REQUEST FOR TENDER RFT #B25-03

Washroom Upgrades
(Fenelon Twp PS, Bobcaygeon PS, IE Weldon SS, Lady Mackenzie PS)

TLDSB ADDENDUM NO. 7

RFT B25-03 LADY
MACKENZIE PUBLIC
SCHOOL

RFT B25-03 STRUCTURAL
UPGRADE AND REPAIRS -
LATERAL SUPPORT OF
MASONRY WALLS AND
LINTEL DETAILS

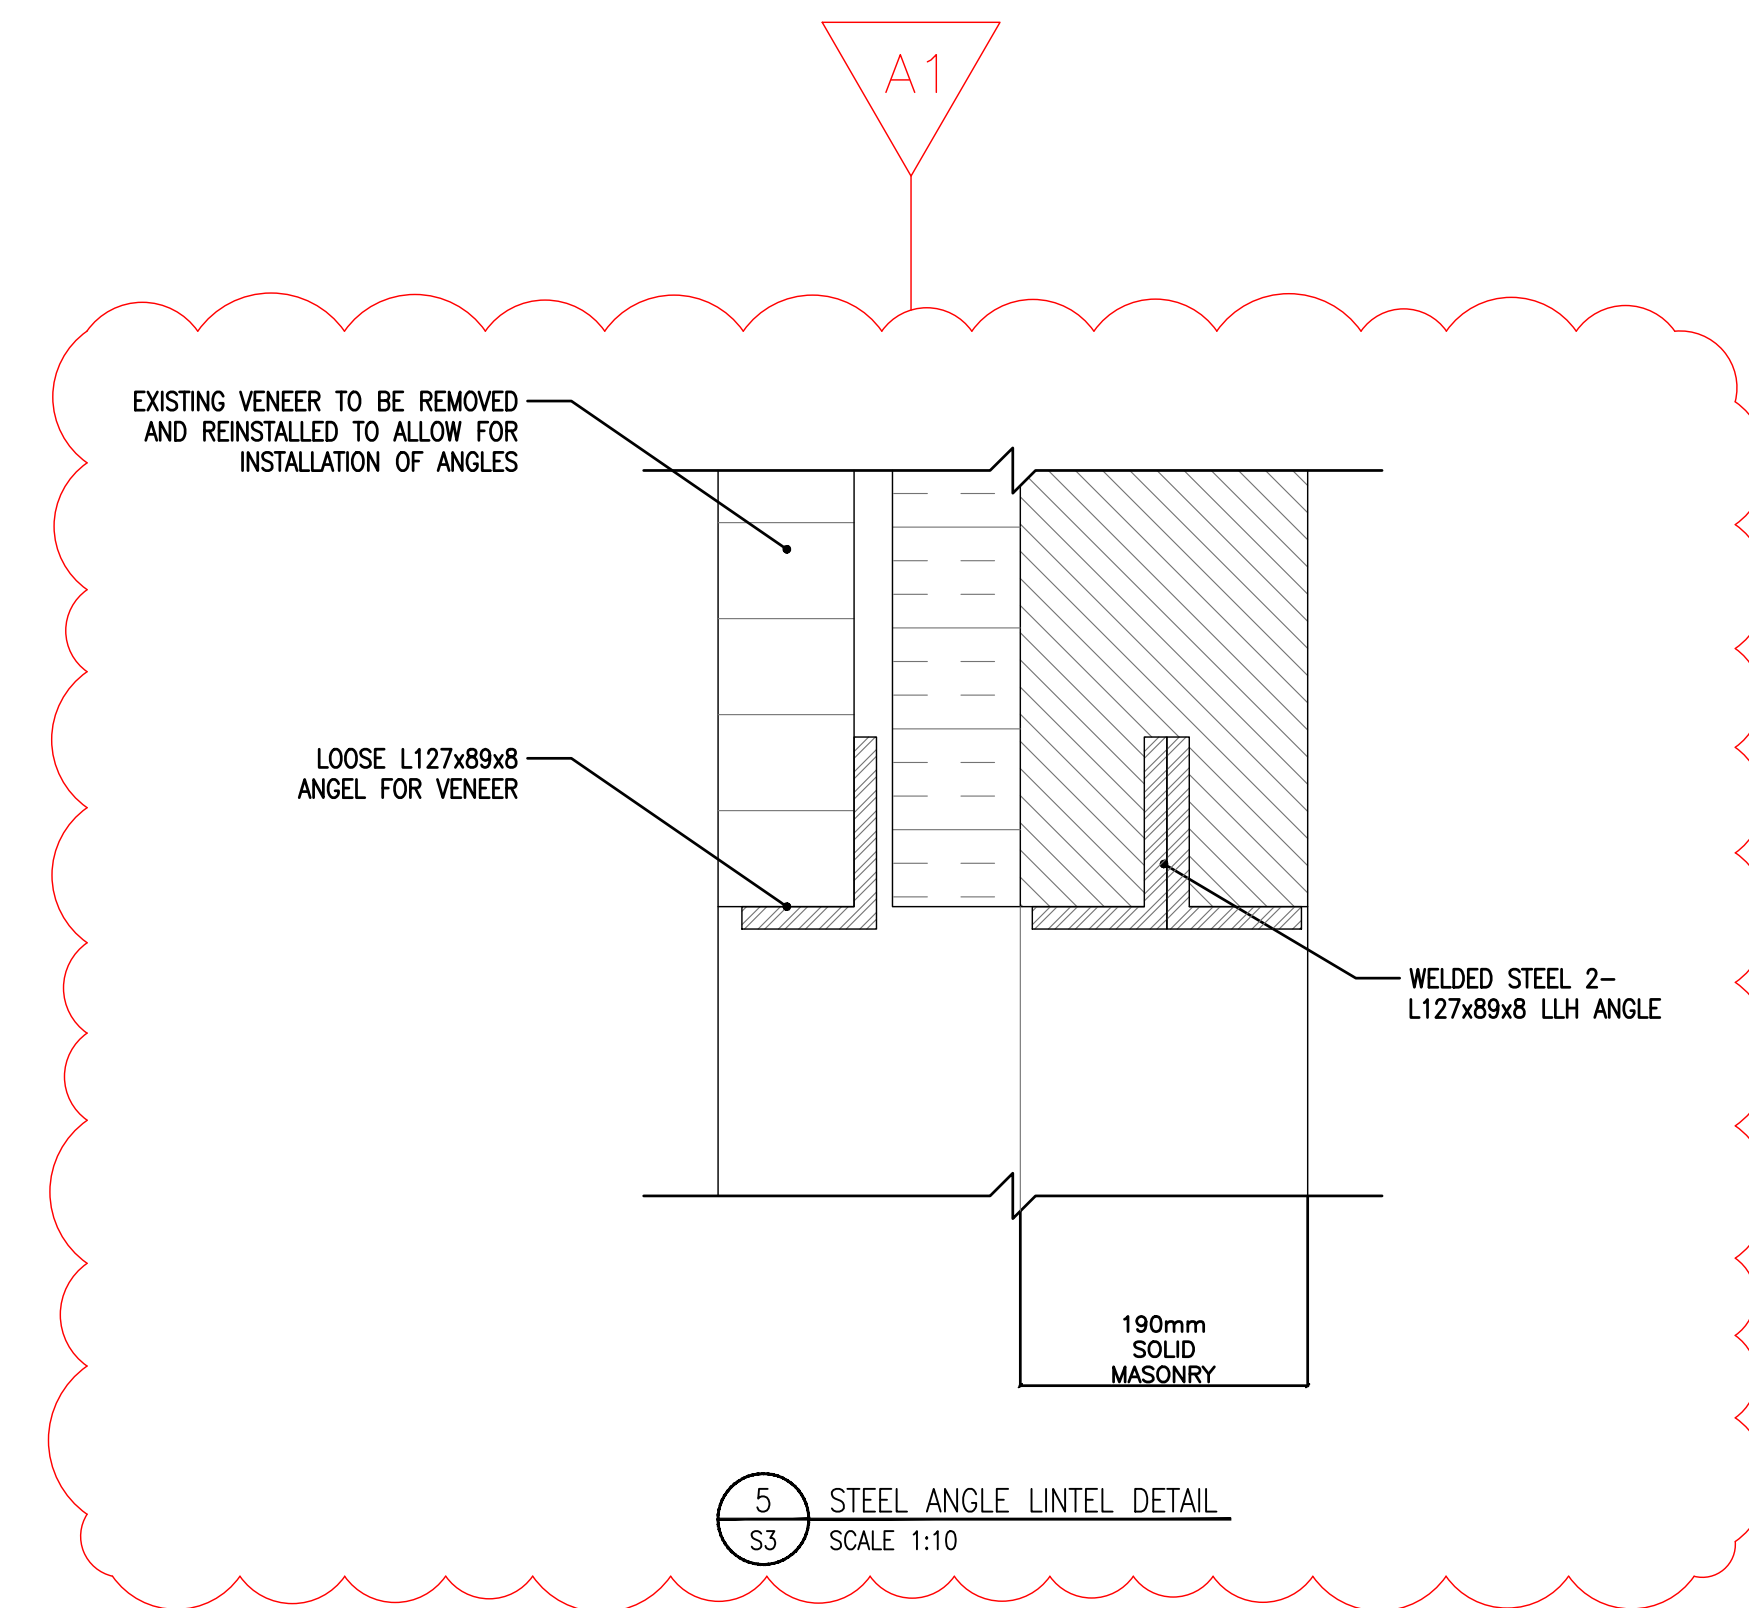
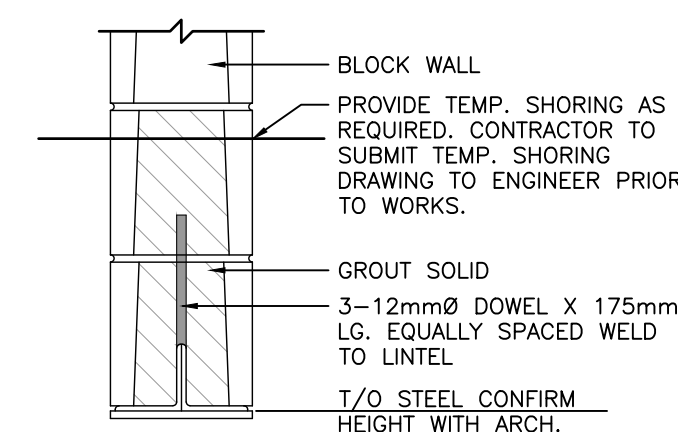
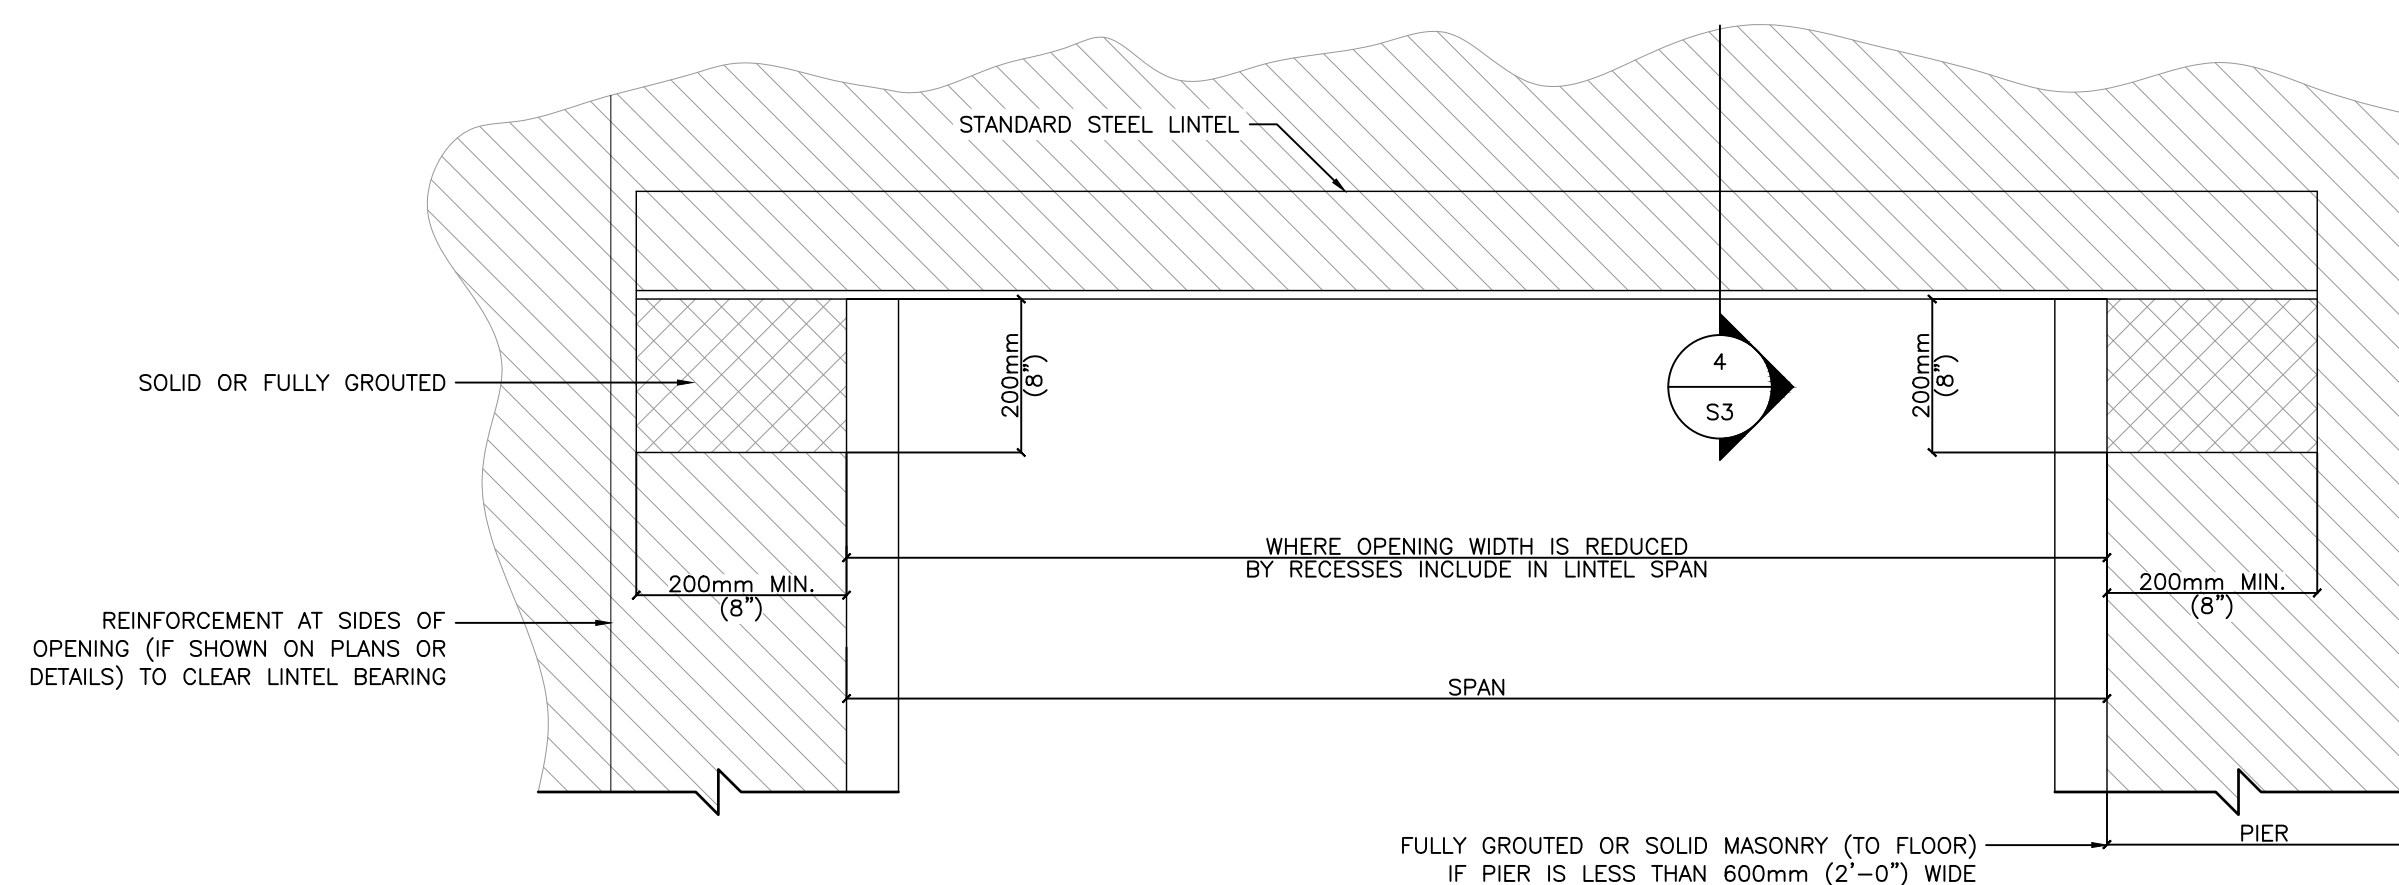
- 3.1. **ADD: Additional lintel to support the outer wythe of the masonry veneer. Refer to attached revised structural drawings S1 and S3.**
- 3.2 **Drawing 4/A800. Refer to attached ASK 001 which revises drawing 4/A800 and the new windows.**
